TIC-AW139-24-0034

UPDATED BASED ON LOEP ATTACHED FOR AMP 139 REV. 0A DATED 29 MARCH 2024

SECTION 6.1.34

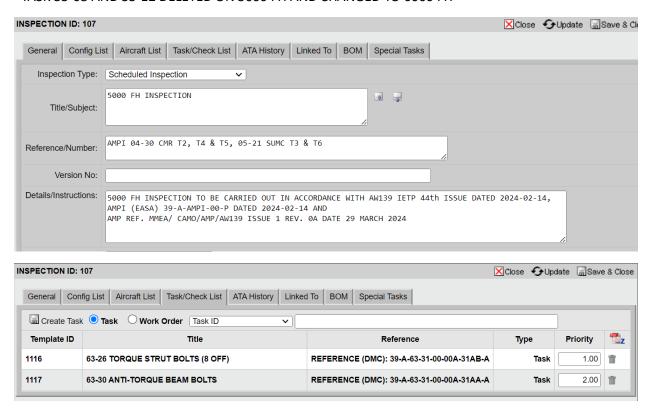
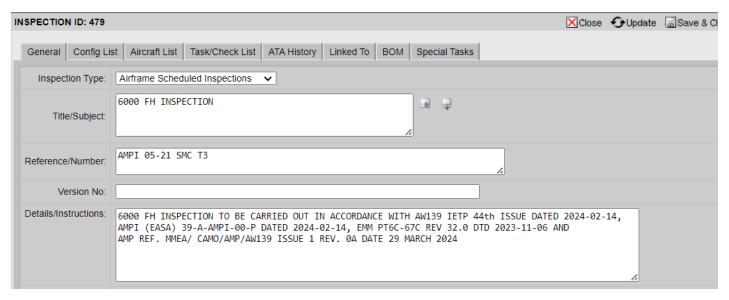
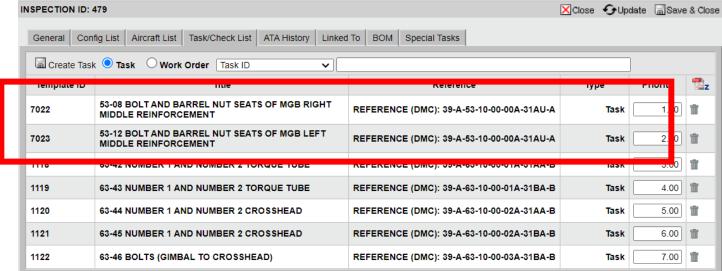
*TASK 53-08 AND 53-12 DELETED ON 5000 FH AND CHANGED TO 6000 FH

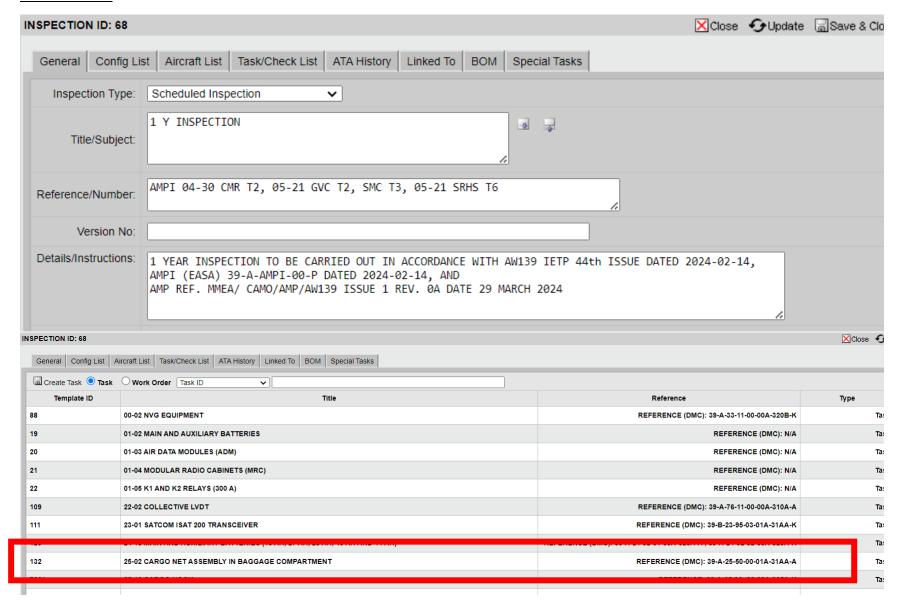
*AS THERE IS UPDATE FOR AMPI (EASA) 39-A-AMPI-00-P DATED 2024-02-14, NOTE 70 HAS BEEN ADDED TO TASK 25-02 ON WORKSHEET

Item	Description						Technician	* Eng. CRS	Date
	25-02 CARGO NET ASSEMBLY [70] REFERENCE (DMC): 39-A-25-50-00-01A-31AA-A								
	DO A DI FOR DAMAGE AND CONDITION NOTE 70: TASK APPLICABLE TO ALL KITS WHICH INSTALL A CARGO NET TO SECURE CARGO. REQUIREMENTS AFTER JOB COMPLETION 1 REMOVE ALL THE TOOLS AND THE OTHER ITEMS FROM THE WORK AREA. MAKE SURE THAT THE								
	WORK AREA IS CLEAN. 2 CLOSE THE ACCESS DOORS 183AL AND 184AR. REFER TO 39-A-06-41-00-00A-010A-A REMARKS:								
	25-16 CARGO HOOK REFERENCE (DMC): 39-A-25-92-00-00A-365A-K
